ADDENDUM NO. 02

**High School Addition & Renovation
Jr. High Addition & Renovation
Intermediate School Controls Renovations
Primary School Controls Renovations
Softball Concessions
Ellettsville, IN 47429**

ADDENDUM NO. TWO

**Richland-Bean Blossom CSC
Additions and Renovations**

EXISTING SITE
CONDITION
PLAN

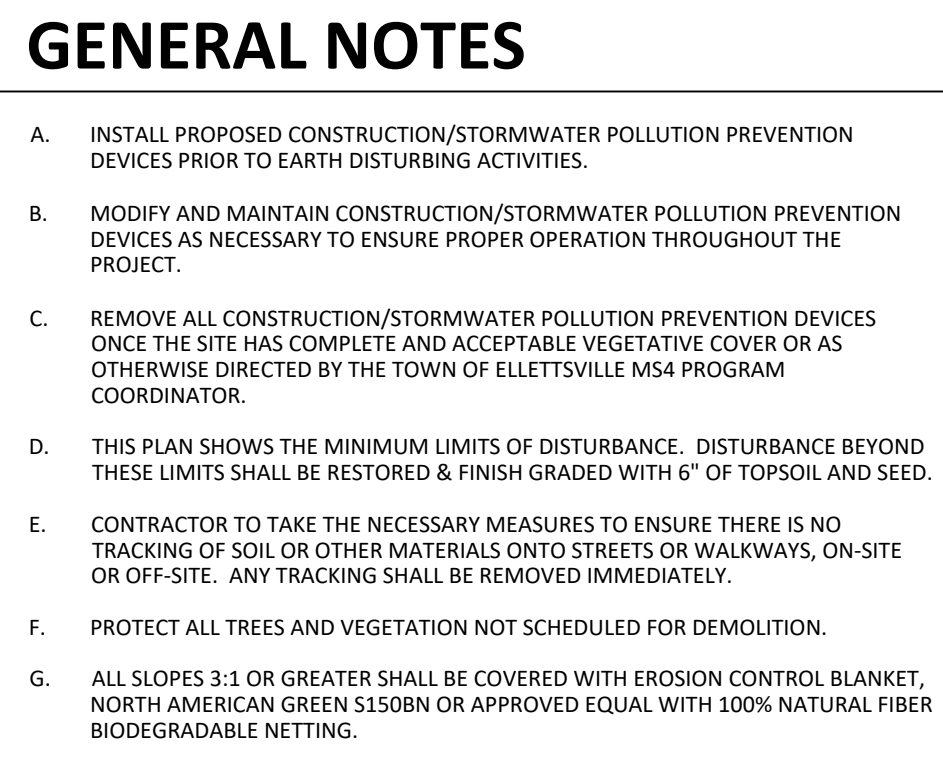
2. C101 – Existing Site Condition Plan – Remove and replace with attached.
 - a) Updated existing utility locations along the high school per field investigation.

EROSION CONTROL PLAN

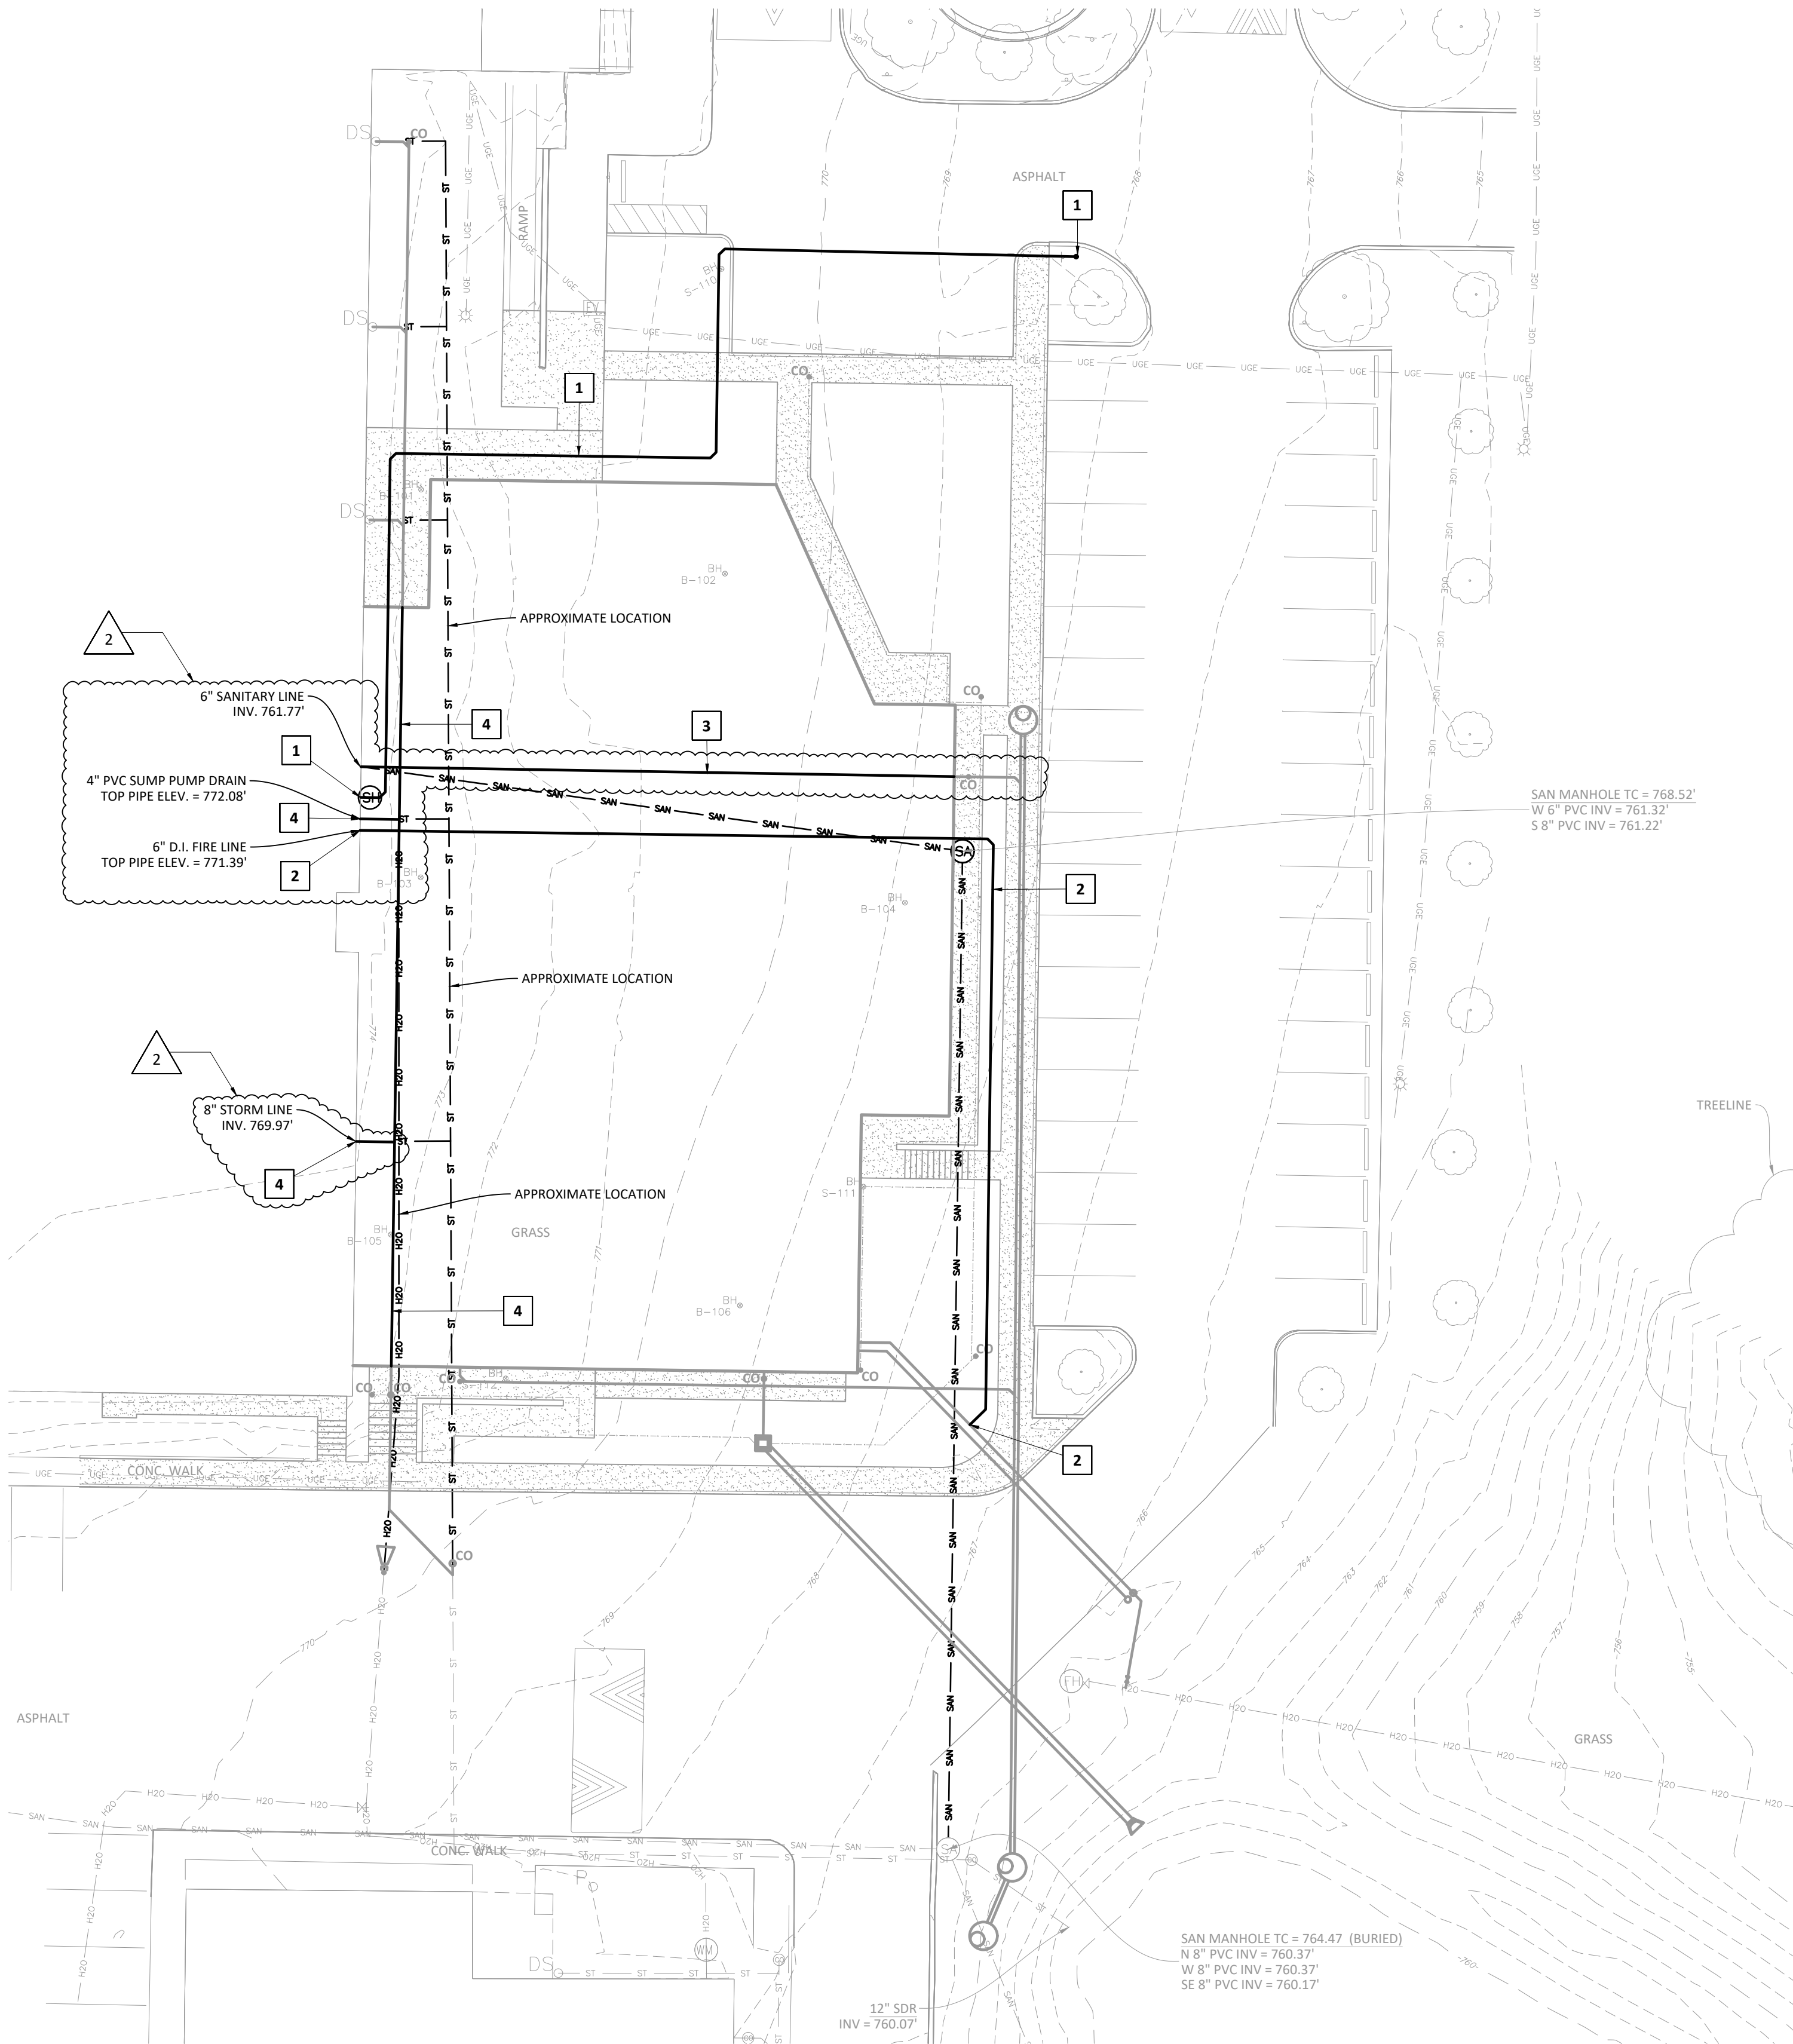
3. C201 – Erosion Control Plan – Remove and replace with attached.
 - a) Revised limits of erosion control fabric to accommodate revised basin grading.
4. C303 – Utilities Preparation Plan – Remove and replace with attached.
